ADDENDUM #1 TO UPDATE #2 TO THE
TECHNICAL DRAINAGE STUDY
FOR
MONTALADO NORTH

W.O. #WL-2123
February 22, 2024

**Re: Addendum #1 to Update #2 to the
Montalado North
Technical Drainage Study**

NOMOGRAPH - INLET CONTROL BOX CULVERT

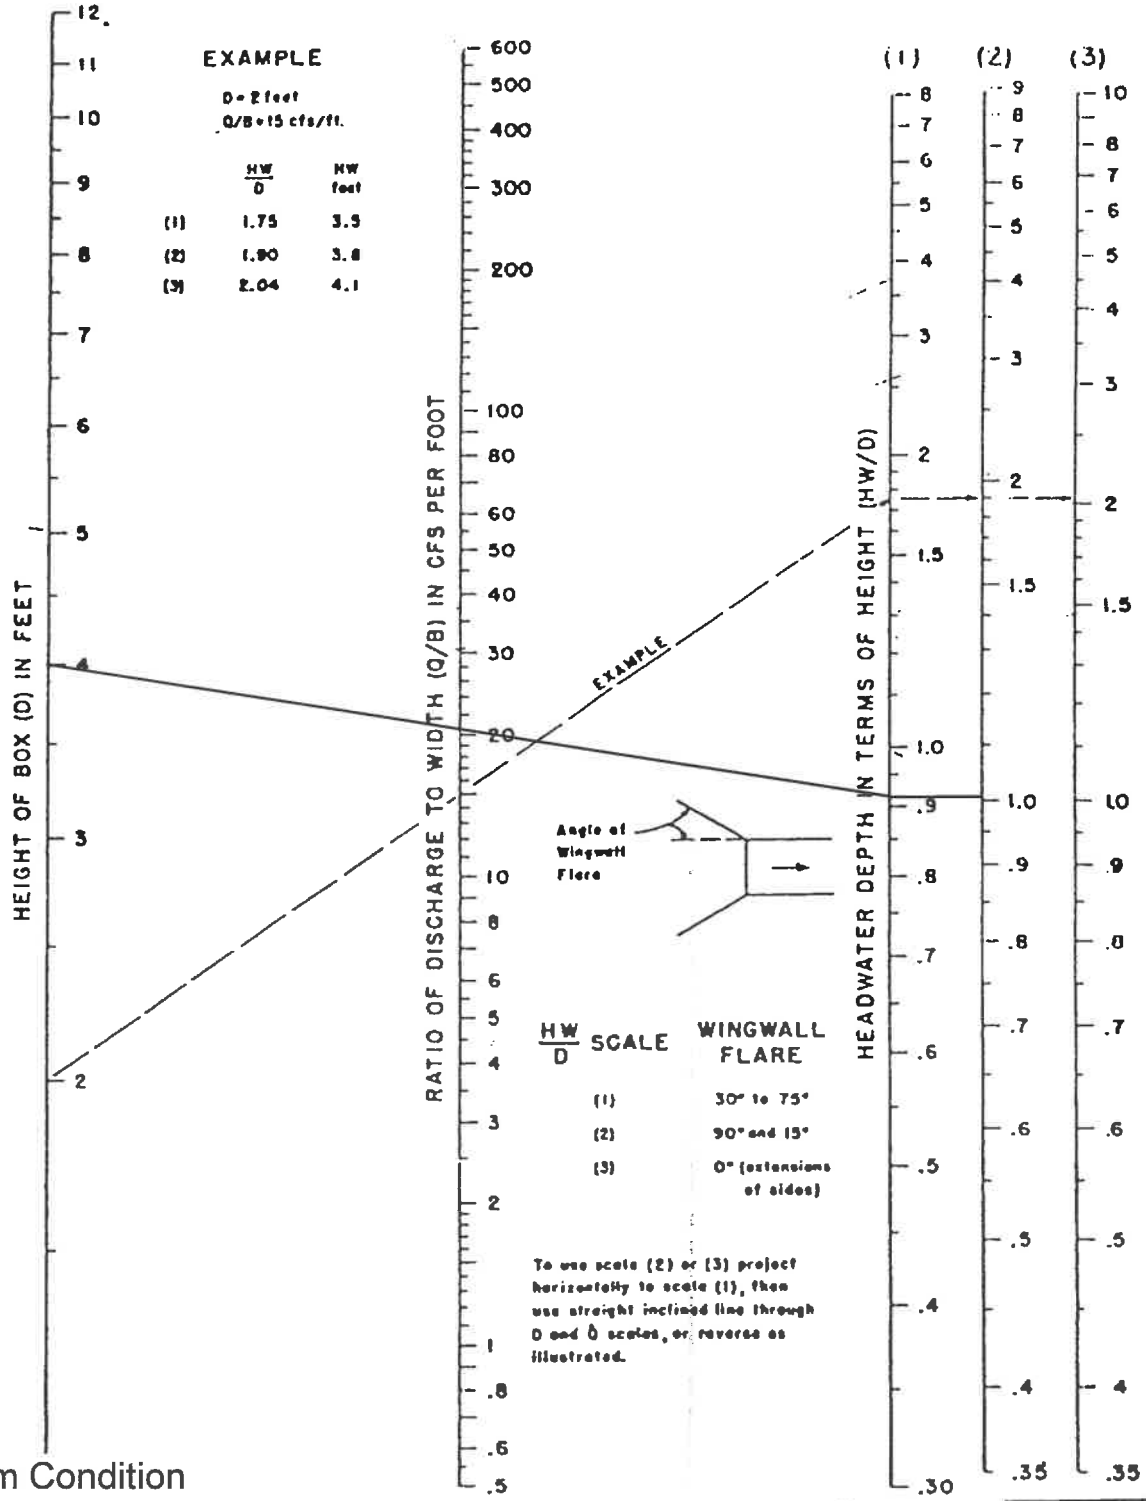
Comment 4. The headwater depth versus the rise of the proposed transition box structure does not meet the 1.5 ratio as stated in Section 1002.4 of CCRFCD HCDDM. Revise design and calculation accordingly.

Response 4. We provided a nomograph with Update 2 that reflected a 1.0 ratio that exceeds the criteria stated in Section 1002.4 of the Manual. This nomograph is provided at the rear of this letter for the convenience of review.

Interim Condition

$HW/D = 1.0, D = 4'$

$HW = 4'$

$Q = 431, B = 20, Q/B = 21.55$
